TRANS/WP.29/2003/38
7 April 2003

PROPOSAL FOR DRAFT SUPPLEMENT 5 TO THE 03 SERIES
OF AMENDMENTS TO REGULATION No. 44

(Child restraint systems)

Transmitted by the Working Party on Passive Safety (GRSP)

Figure 0 (c): ISOFIX Top tether connector (hook type) dimensions

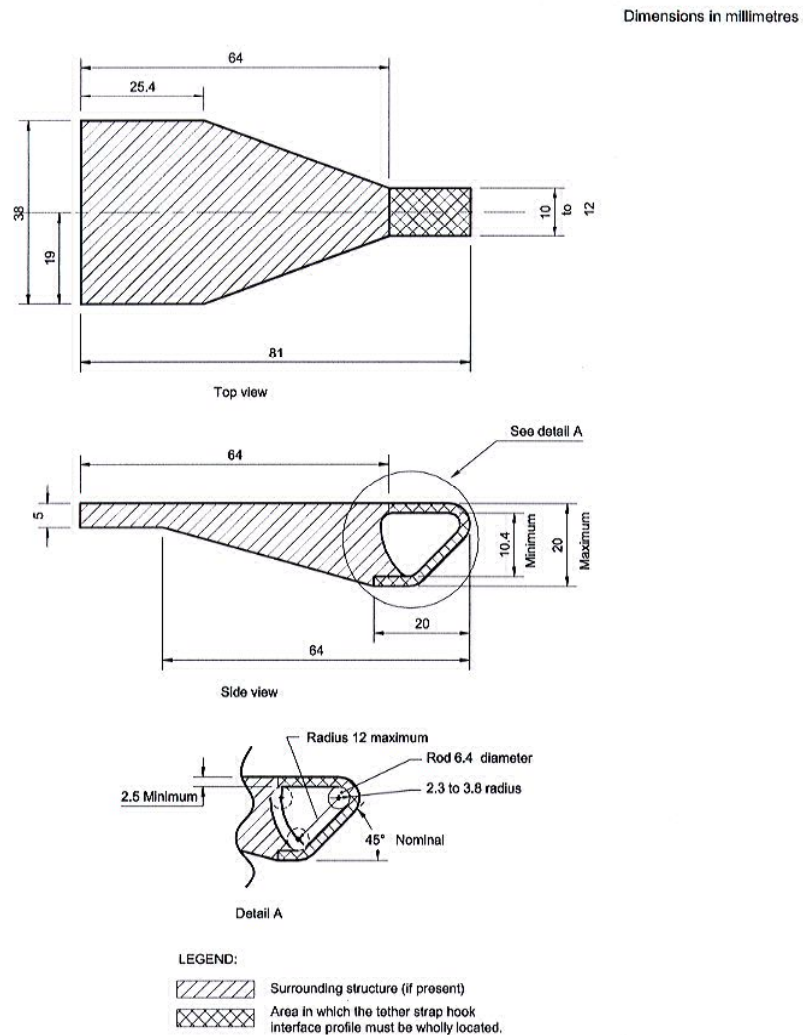
6.3.3.2.3. Dimensions

Engagement dimensions for ISOFIX top tether hooks are shown in figure 0 (c).

Figure 1"

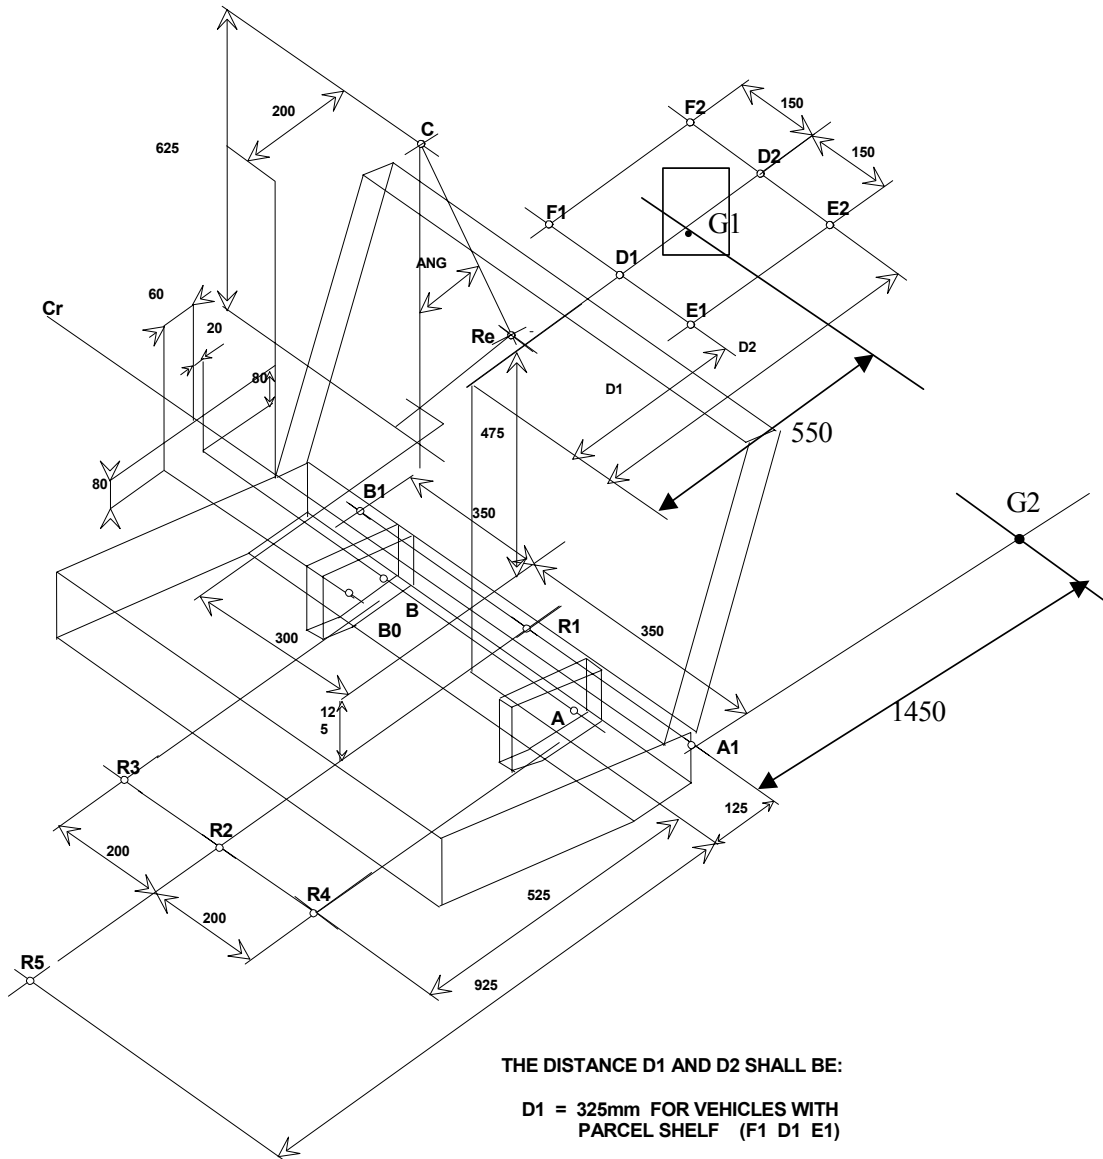
Figure 1, amend to read:

THE DISTANCE D1 AND D2 SHALL BE:

D1 = 325mm FOR VEHICLES WITH
PARCEL SHELF (F1 D1 E1)

D1 = 1025mm FOR VEHICLES WITH
FOLDING BACK REAR SEATS
(ESTATE TYPE) (F2 D2 E2)

DIMENSIONS REFERRING TO Cr
ARE TOLERANCED WITH: ± 2 mm
EXCEPT FOR DISTANCE FLOOR TO Cr ± 10 mm

DISTANCE C - Re = 550mm
ANGLE "ANG" = 30° MAXIMUM

Figure 3 "

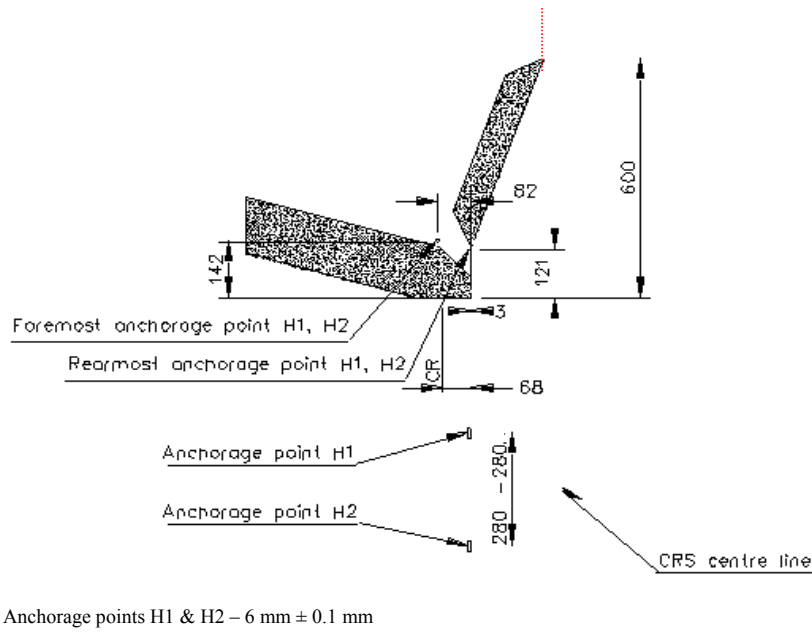
Insert a new figure 3, to read:
